V2500 Propulsion System - Nacelle **SERVICE BULLETIN**

Subject: Transmittal of Revision 2 to Service Bulletin Number V2500-NAC-24-0016

NACELLE – ELECTRICAL POWER – CONTROL HARNESS, VARIABLE SPEED CONSTANT
FREQUENCY (VSCF) GENERATOR – CLIPPING POINT BRACKET – RH NACELLE -
MODIFICATION OF

V2500-NAC-24-0016

Clipping Point Modification – RH Nacelle Only
Figure 1 (sheet 1)

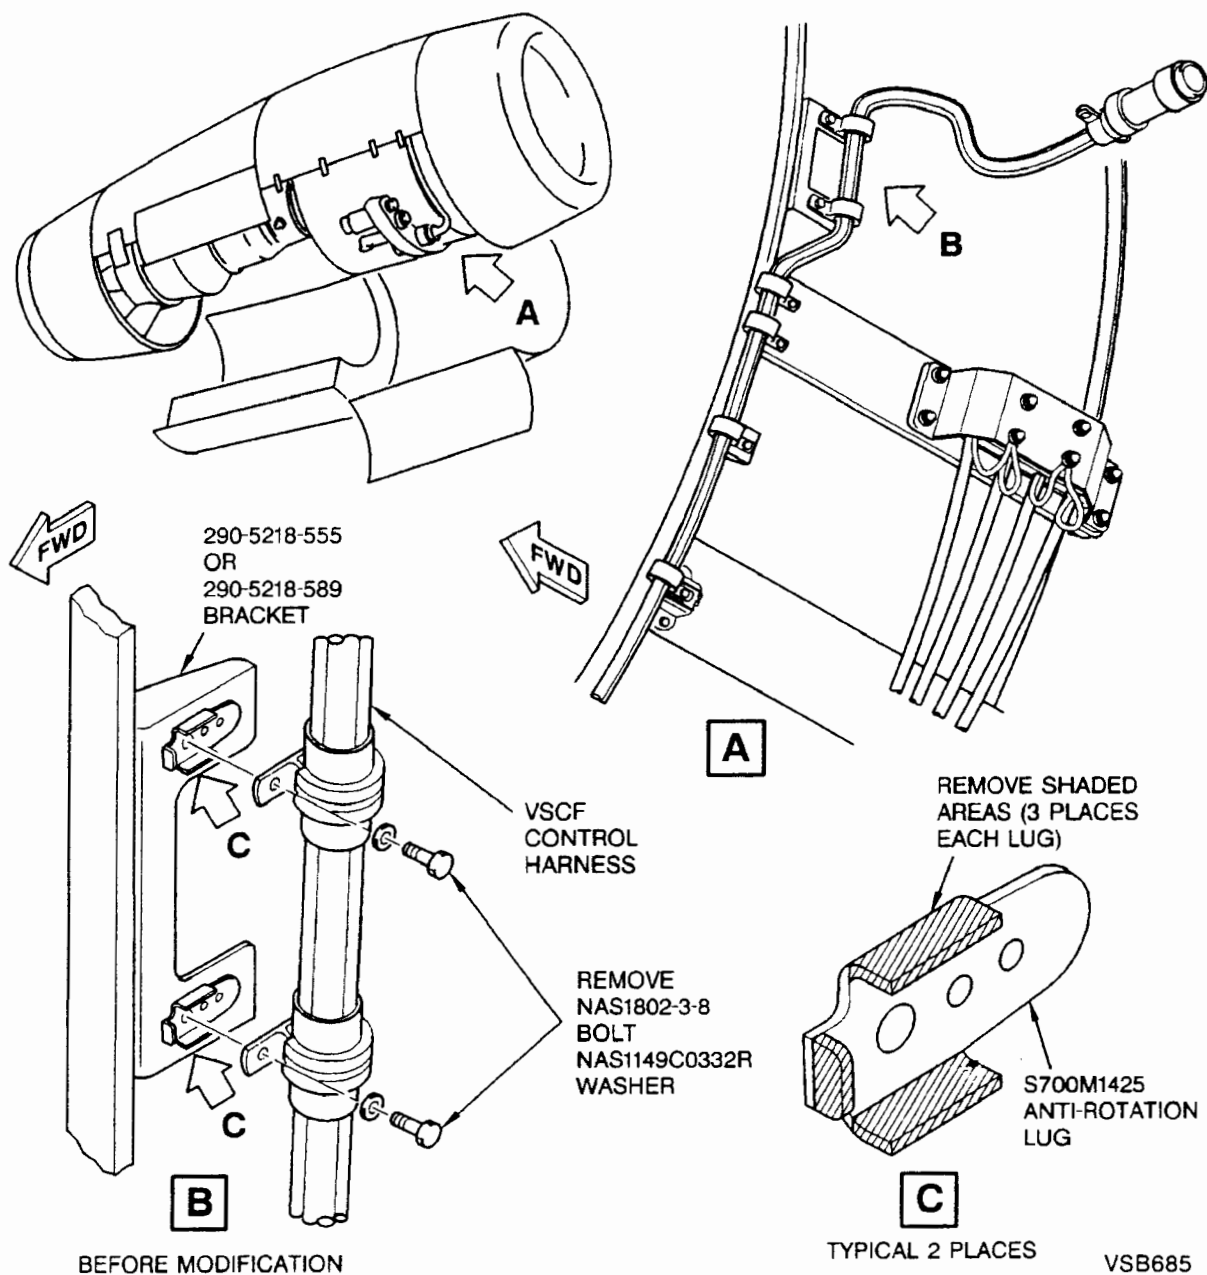
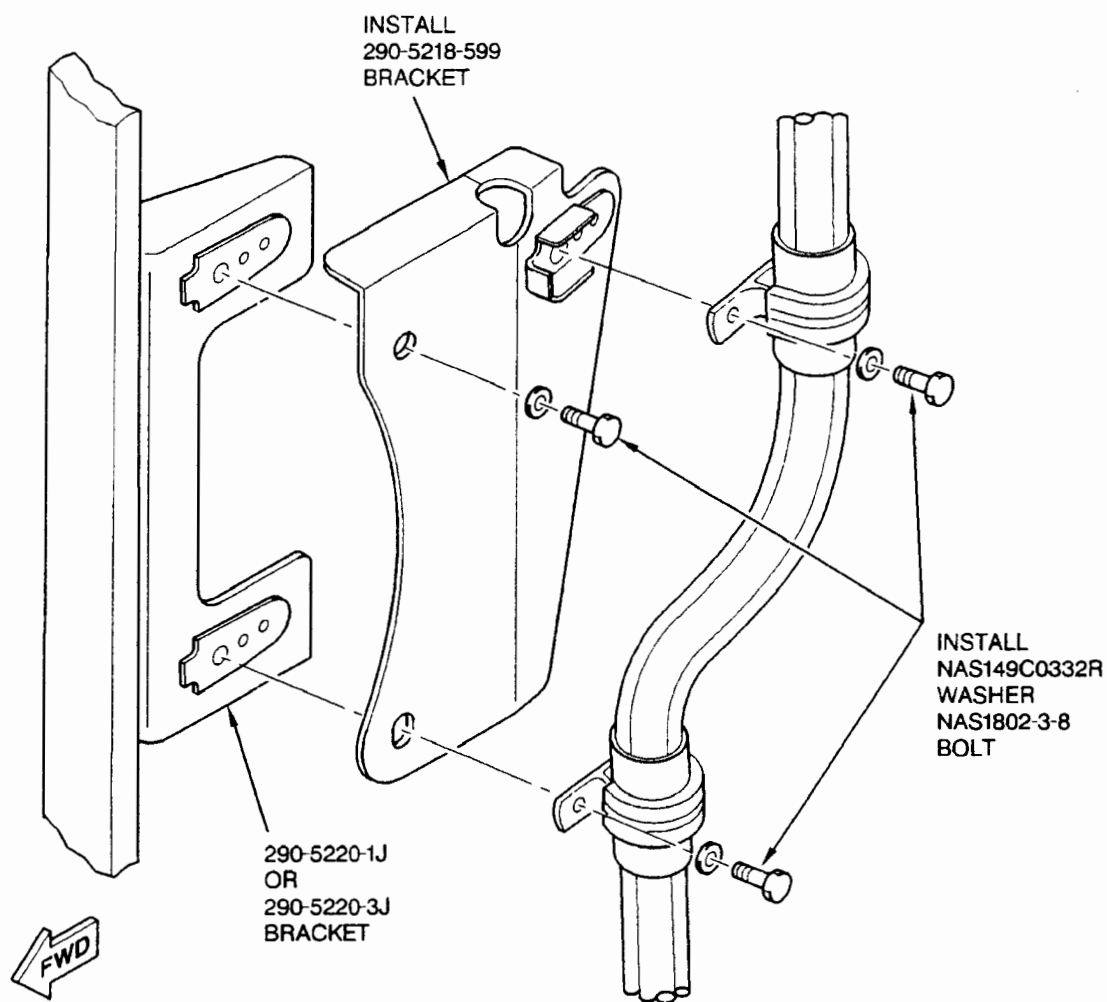
Interference between a VSCF control harness clipping point and the pylon-mounted hydraulic disconnect panel has been detected in the RH nacelle.

To modify the existing clipping point to eliminate the possibility of interference with the pylon-mounted hydraulic disconnect panel.

The existing clipping point bracket is modified and a new bracket is installed.

- A. On the RH nacelle, open the lower fan cowl. Refer to the MD90 Aircraft Maintenance Manual, Chapter 71-13-00.
- B. Remove the clamps from the 290-5218-555 or 290-5218-589 bracket assembly. Keep the attaching hardware for later use. Refer to Figure 1.

- C. Remove material from the S700M1425 anti-rotation lugs. Refer to Figure 1.
- D. Reidentify the modified 290-5218-555 bracket assembly as the 290-5220-1J. Reidentify the modified 290-5218-589 bracket assembly as the 290-5220-3J. Use rubber stamp and ink (CoMat 06-073). Refer to the IAE Standard Practices/Processes Manual, Chapter 70-09-00.

- E. Install the 290-5218-599 bracket and clamp on the 290-5220-1J or 290-5220-3J bracket assembly. Refer to Figure 1.
- F. Install the clamp on the 290-5218-599 bracket. Refer to Figure 1.
